GENOA CHARTER TOWNSHIP
PLANNING COMMISSION
PUBLIC HEARING
AUGUST 11, 2025
MONDAY
6:30 P.M.
AGENDA

Attention:	Amy Ruthig, Planning Director
Subject:	South Latson Commercial Development – Special Land Use and Site Plan Review #2
Location:	1111 S. Latson Road – east side of Latson Road, south side of Grand River Avenue
Zoning:	GCD General Commercial District

At the Township’s request, we have reviewed the revised submittal materials requesting special land use review/approval for a drive-through restaurant within a multi-tenant commercial building (plans dated 5/27/25).

TITLE: **SITE PLAN**

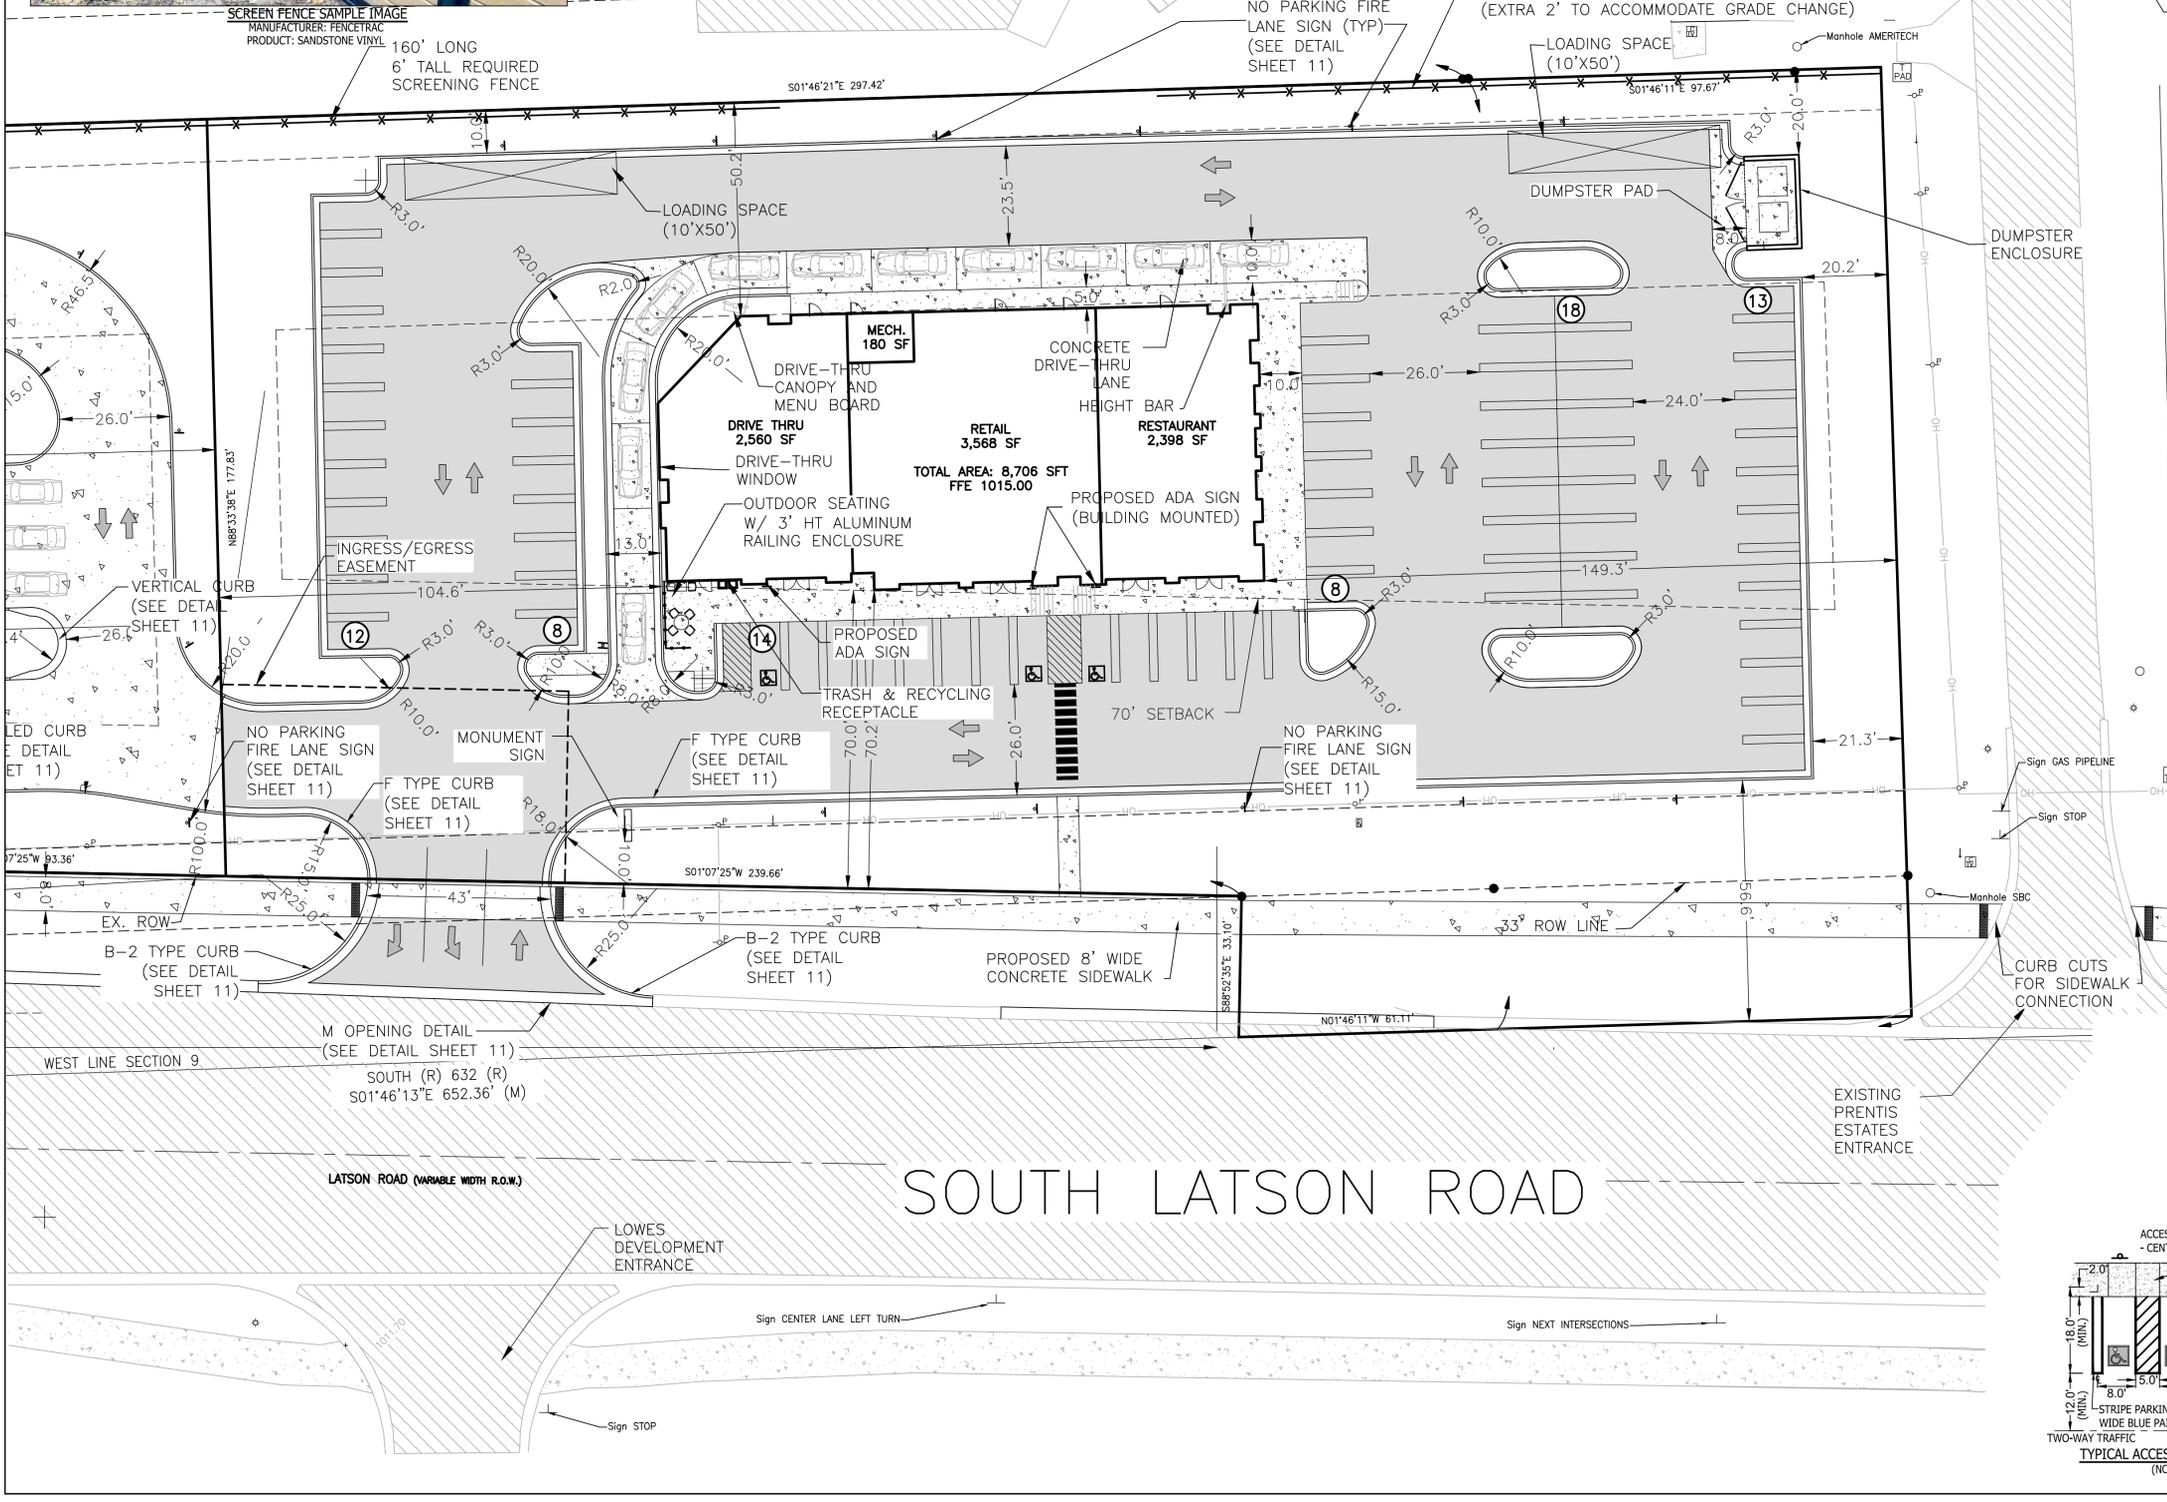
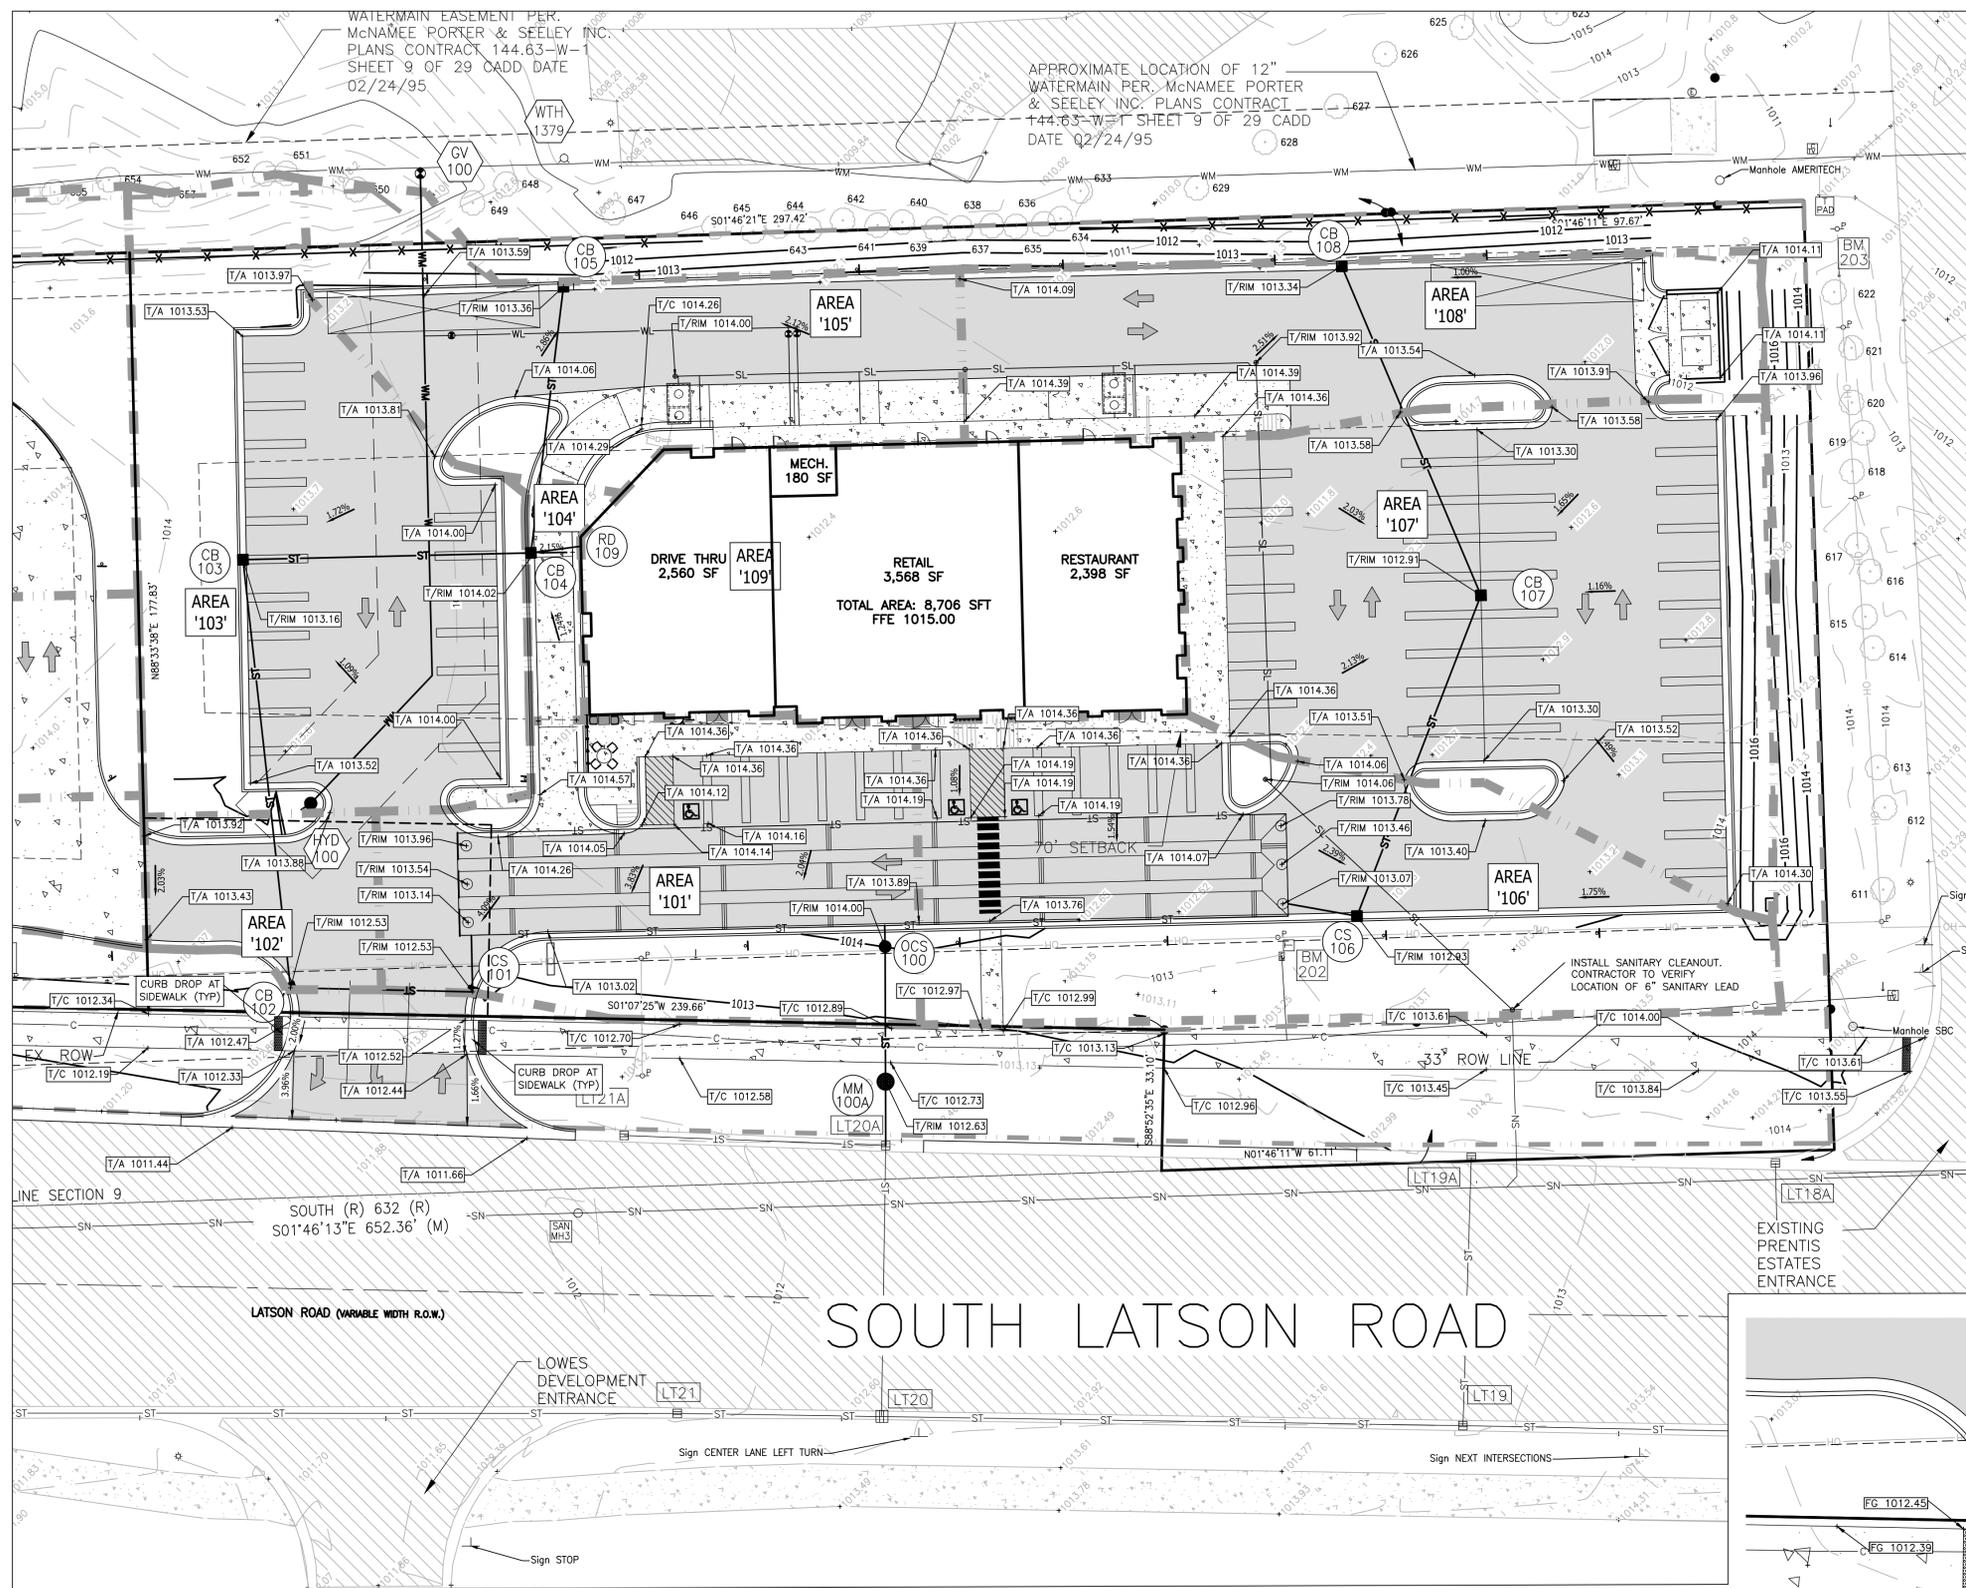
- 5. Parking.** Based on the parking calculations included on Sheet 5, the project requires 73 parking spaces. The site plan provides 73 parking spaces, including the 3 required barrier-free spaces.
